Access Compliance Report Public Rights-of-Way (Curb Ramps)

Main Street: CRAWFORD_CANYON_RD		Cross Street: N/A		Location:	NW
ADA ID: RPAT220225152023	Ramp Type:Type 1 - Perpendicular	Initial Pass/Fail: Pass	Overall Compliance: No	Severity Score:	10
Codes/Mitigation Info/Possible Solution			Field Measurements/Component Compliance

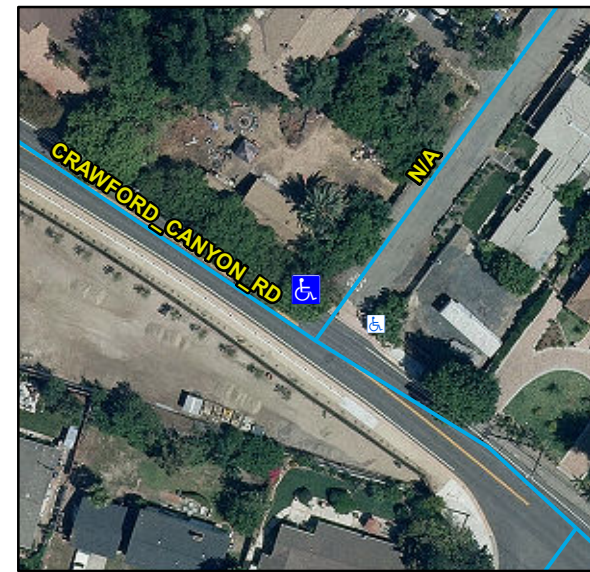
Remove & Replace Detectable Warning System.
Remove & Replace Gutter.
